BUKTI KORESPONDENSI ARTIKEL PADA JURNAL INTERNASIONAL BEREPUTASI

Judul	:	Understanding of Petobo liquefaction flowslide by 2018.09.28 Palu-Donggala Indonesia earthquake based on site reconnaissance
Jurnal	:	Landslide Journal
Volume	:	18
Tanggal publikasi	:	06 Juni 2022
ISSN (p)	:	1612-510X
ISSN (e)	:	1612-5118
Halaman	:	3163–3182
Penerbit	:	Springer Nature
SJR jurnal	:	1,918 (2021)
Quartile	:	Q1 (Scopus)
Cite Score	:	10,6 (2021)
Penulis	:	Rini Kusumawardani, Muhsiung Chang, Togani Cahyadi Upomo, Ren-Chung Huang, Muhammad Hamzah Fansuri, Galih Ady Prayitno

Understanding of Petobo Liquefaction Flowslide by 2018.09.28 Palu-Donggala Indonesia Earthquake Based on Site Reconnaissance --Manuscript Draft--

Table 1. Responses to Comments by Editor

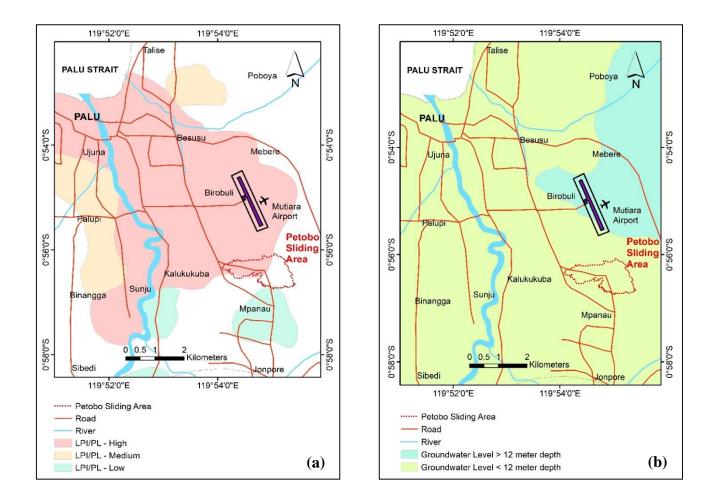
-		The state of the second second
5	Need to explain related	Thank you for your comments.
(page 6	slip field and bedrock	My revision concerning to your advice as follows,
line 54-60	components	"The Palu-Koro fault in Palu Valley has experienced an evolution with age
and		for two distinct alluvial fan units, i.e., old alluvial fans and young alluvial
page 7		fans (Bellier et al. 1999). The Petobo flowslide area is situated on the old
line 1-2)		alluvium fan deposit formation (Qf2) and the alluvial, flood and old river
		channel deposit formation (Qal) of the Palu river valley. The alluvial and
		flood deposit consists of mostly sand, silt and clay (Pyi et al. 2015).
		Furthermore, the alluvial fan deposit is typically composed by gravel-sand
		transitions and it often exhibits similar gravelly soils with a narrow particle
		size distribution. Due to poor particle gradations, the soil contains a series

bedrock. perhaps it will	permeability, with a thickness of about 3.5 m. A suspect area with a high
	show how susceptible	risk of liquefaction occurrence is in the alluvium deposit. In this area, the
	liquefaction occurs	depth of groundwater level is less than 12 m. The alteration of soil
		behaviour in each soil layers could be occurred when experienced by
		seismic wave. When the seismic wave propagated from the bedrock
		through the saturated sand soil layers, it lead the decreasing of effective
		soil stress. A susceptibility of liquefaction could be reached when pore
		water pressure equal to initial effective stress. In Palu city and
		surroundings, a suspect area with a high risk of liquefaction occurrence is in
		the alluvium deposit. Details of liquefaction susceptibility and groundwater
		level in Palu and surrounding can be seen in Fig. 4."

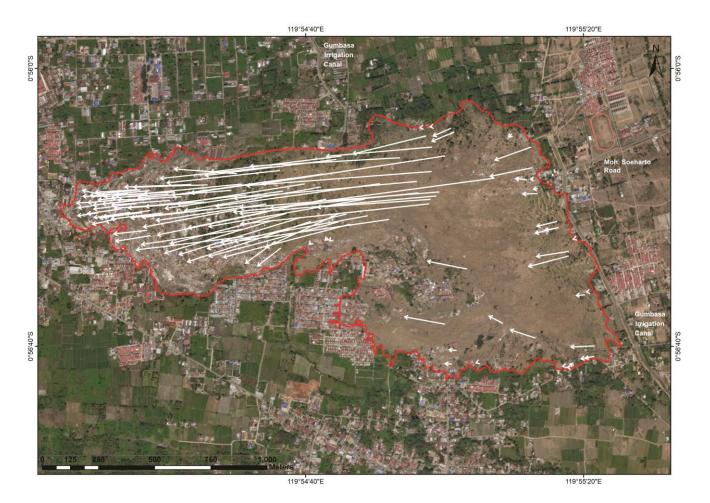
7 (Page 19	Not clear on the figure 12	Thank you for comment The revision for the Figure 12 as follows,
line 53-54)		Port Port
		"Fig. 12 Displacement vectors of surface objects identified by onsite investigation as well as based on Google Earth satellite images before the
		after the earthquake. Purple dots are the initial locations and pink dots are the ending positions. The white arrows are the direction of displacements. Base photo is taken from Google Earth satellite image of 2019.05.23."
8 (Page 21 Line 13-24)	Need to connect with rainfall data and water table data. inundated the paddy field must be supported with a reference while the soil of paddy field has specific characteristic different with another soil, especially with a hard pan under the paddy field soil	Thank you for your comments. Concerning to inundated paddy field, we revise the text as follows, "As indicated by local residents and in Google Earth images, Gumbasa irrigation canal was constantly filled with water before the earthquake (Photos 1 & 2; Fig. 10) and the paddy fields were also inundated with water for about 8-months plantation time annually, which are based on our site reconnaissance as summarized in Table 1. During the plantation, the paddy fields would be submerged at least by water about 30-50 cm above the soil surface for plantation purposes. Furthermore, the intensive irrigation systems to paddy fields from Gumbasa canal which would constantly supply the local ground water tables under the paddy fields. In our opinion the rainfall would appear not really affect the increase of ground water table under the paddy fields as reference to Fig. 14, which clearly indicated the absence of rain a week before the flowslide occurred.

Fig. 14 Daily rainfall intensity during September 2018 in study area which clearly indicates the absence of rain a week before the flowslide occurred (Meteorological, Climatological and Geophysical Agency 2021).

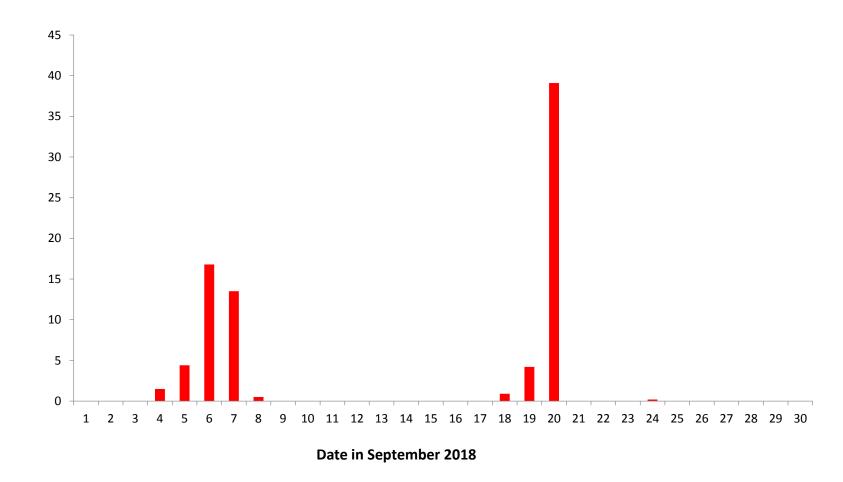
2. Please add the data of rainfall, model of ground water and water table depth, so the discussion more accurate

9 (Page 21 line 34-36)	should be clarified with rainfall data, and a stratigraphic cross section to predict how the model groundwater at the study site	45 40 35 30 25 20 15 10 5 0 1 2 3 4 5 6 7 8 9 10 11 12 13 14 15 16 17 18 19 20 12 23 4 5 6 7 8 9 10 11 12 13 14 15 16 17 18 19 20 12 22 23 24 25 26 27 28 29 30 Date in September 2018Fig. 14 Daily rainfall intensity during September 2018 in study area which clearly indicated the absence of rain a week before the flowslide occurred (Meteorological, Climatological and Geophysical Agency 2021). In view of mostly unline Gumbasa irrigation"Thank you for your comment. In this paragraph, we would like to explain when the Gumbasa canal was broken due to the earthquake, it would have played an important role on the ground failure at Petobo. Because of an intensive irrigation system in this area with gentle slopes, it had caused the liquefaction phenomenon even more severe.
